Attachment G:

Response to Transport Queries

TRANSPORT ENGINEERING RESPONSE LU23031 & SC23032 29 HAMILTON STREET, GORE

1. Further to the Council's Request for Further Information dated 13 June 2023, this letter sets out our response to the transport related matters in the order in which they were raised.

Figure 1: Unit 24 Access Separation

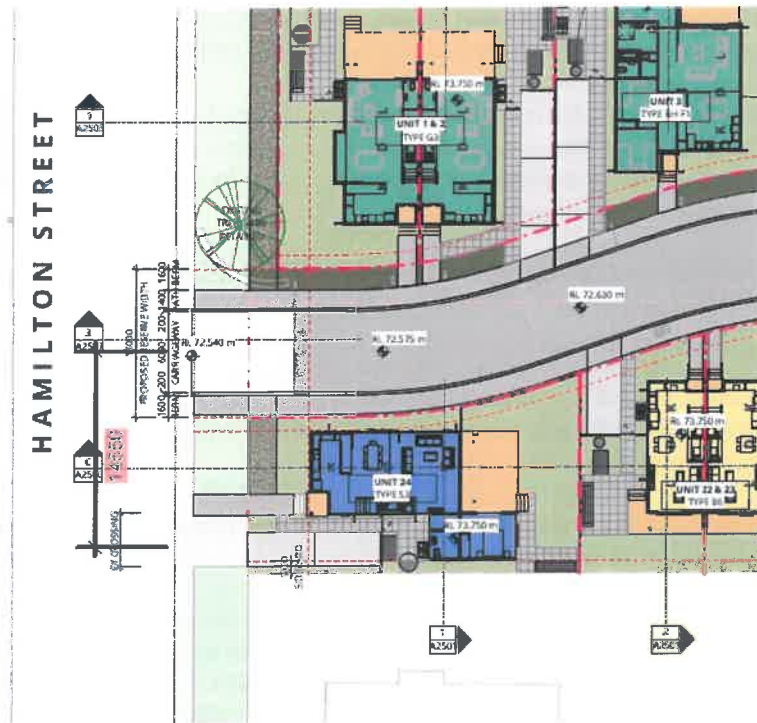
31. Detail the separation distance from the vehicle access directly onto Hamilton Street and the development access. In accordance with Table 3.3c in the Bylaw, these require a minimum separation distance of 19m from the property boundary closest to cul-de-sac road. A dispensation will be required. Please assess.

17. The vehicle crossing on Hamilton Street serving Unit 24 is located approximately 14.5m south of the proposed cul-de-sac road.
18. Gore District Council *Subdivision, Land Use and Development Bylaw* (3.3.18) refers to minimum access spacing requirements set out in Tables 3.4A-C (noting that Table 3.4C appears to have been incorrectly labelled as Table 4.3C). This refers to Standard Drawing R14, however this drawing has been omitted from the Bylaw. Either way, the Table is based on guidance from the Transit New Zealand (now Waka Kotahi NZ Transport Agency) *Planning Policy Manual* which specifies a separation distance measured from the centreline of the proposed road to the centreline of the proposed access⁴. Given that the proposed access is separated by a distance of 14.5m, a dispensation is required for the 4.5m shortfall.

19. The separation distance is identified in **Figure 1** below.

20. In this situation, the combination of the volumes from the proposed cul-de-sac road and Unit 24 are low – such that conflict between two simultaneous turning manoeuvres from both locations are unlikely. Hamilton Street is also wide, flat and straight such that sight distance will not be impeded. Accordingly, safety is unlikely to be compromised as a result of the proposed location.
